The machines arrived on July 17, 2007.

Following a detailed inspection, all machines were setup and booted to Sugar. Then rebooted into a looping configuration of the on board diagnostics. All machines operated for about three weeks with NO functional failures. After several days of operation, teardown inspections were started and a total of 10 machines were broken down completely and inspected in detail.

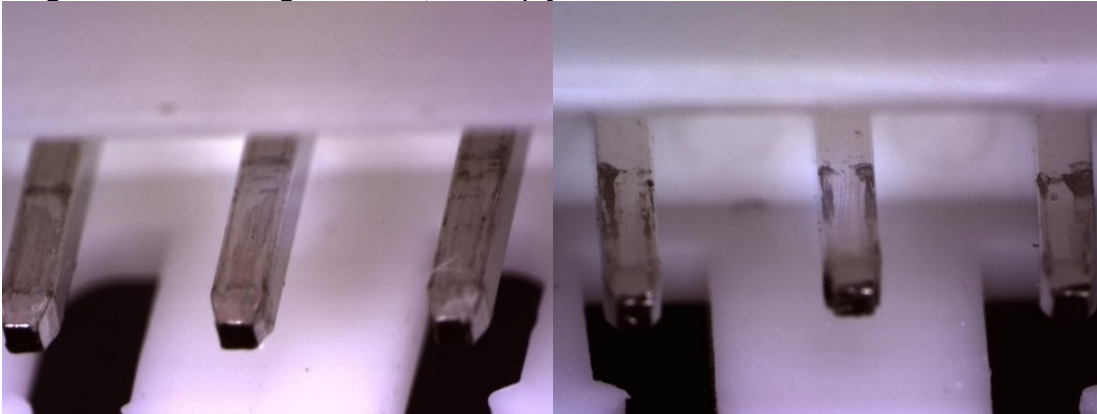
There were several observations regarding connectors. Beginning with the WiFi antenna connectors. There were two combinations. The connectors on the board were always gold plated. There were two different vendors for the female connector used on the cable, one was gold plated and one looked tin plated. Of the four machines with a tin on gold connector combination, there were six metal slivers in or around the ANT1 and ANT2 connectors on the board. These slivers appear to be shavings of plating material. Of the six machines using gold on gold connectors, only two very small slivers were found. These clearly caused no problems but they do have the potential to do so.

Several connector pairs have mismatched plating types, with gold on one side and tin on the other. And pairs are inconsistent with gold on gold in some machines while tin on gold in others. Gold flash is possible in some that appear tin, but it was not observed. This may be a supply issue but if you are paying for gold, you should get gold.

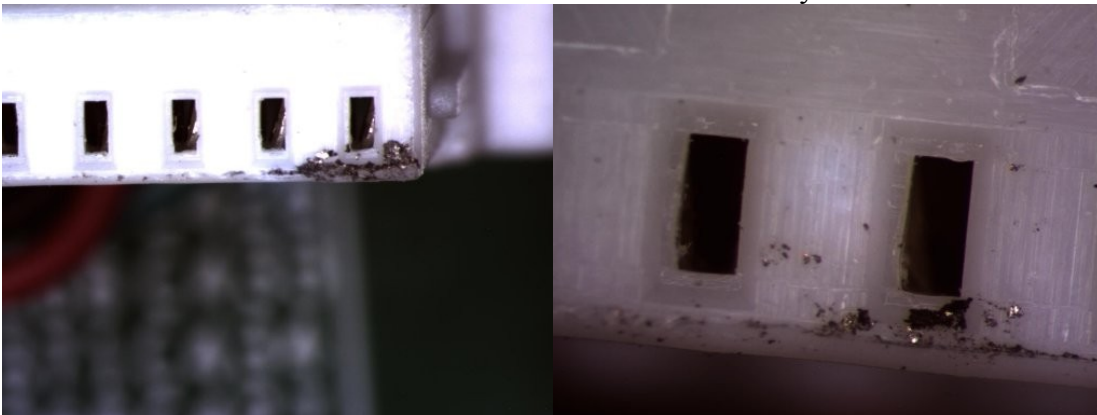
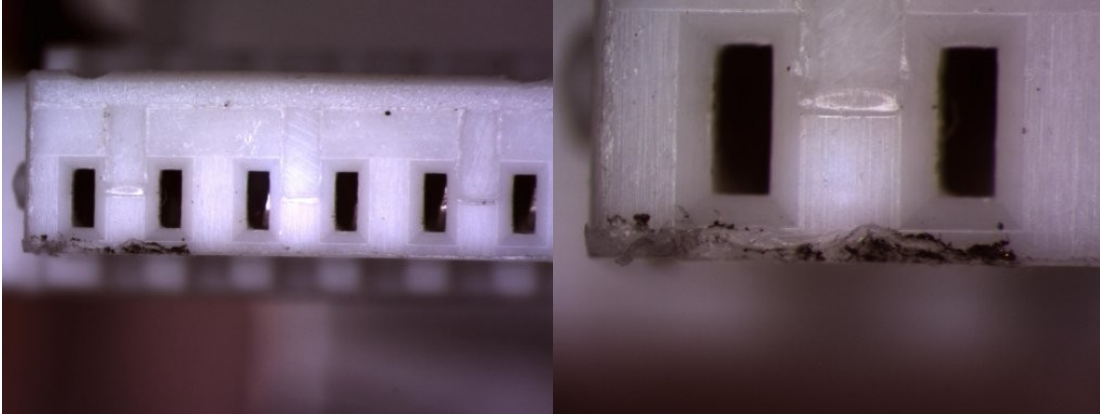
This brings up the potential of fretting corrosion on the tin on tin connectors (or tin on gold for that matter). The battery cable to cable connector mounted under the handle is a good example. Photos of this connector show dark deposits of tin oxide present which is a sign of either fretting corrosion, or simply oxidized tin resulted from the first insertion.

Machines which have experienced vibration and/or thermal cycling, should be disassembled and inspected for signs of fretting corrosion, especially on the battery cable connector. The floating nature of this design should prevent relative motion, and is good practice. Still, a resistance check and visual inspection of connectors from thermal and vibration test machines, will be important to verify the design.

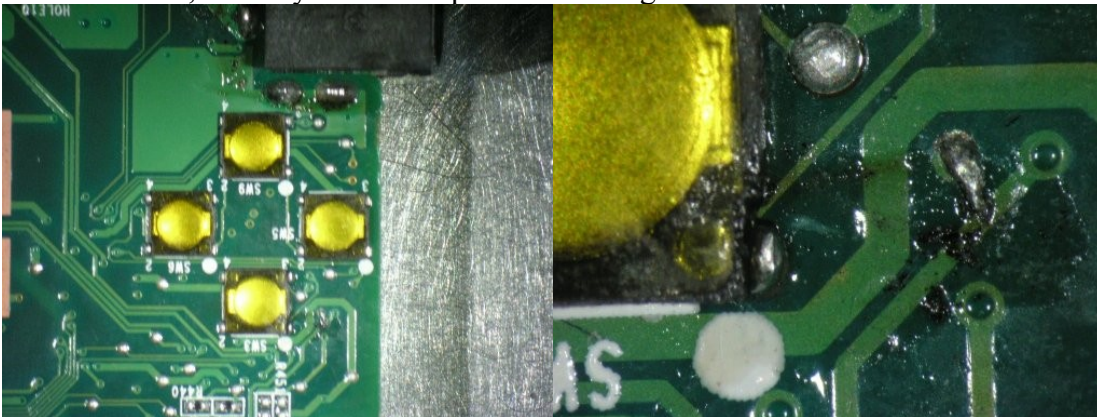
Connectors CN25 and CN26 are identical to CN22. Removing the cables from CN25 and CN26 is straight forward. However, removing the cable from CN22 is made more difficult by the solder bump from a feed through just in front of the female end.

The locking detent feature is a bump on the bottom of the female connector and when pulled out, the detent needs to ride up out of its notch and will tip the outside edge down. The solder bump interferes with this motion and makes it difficult to withdraw. The tendency to pull on the wires rather than the connector housing has the potential to damage the connector contact pins and/or the housing. This may be a service issue as well as an issue on the production line. When the opportunity is available, moving this solder bump slightly would be advised.
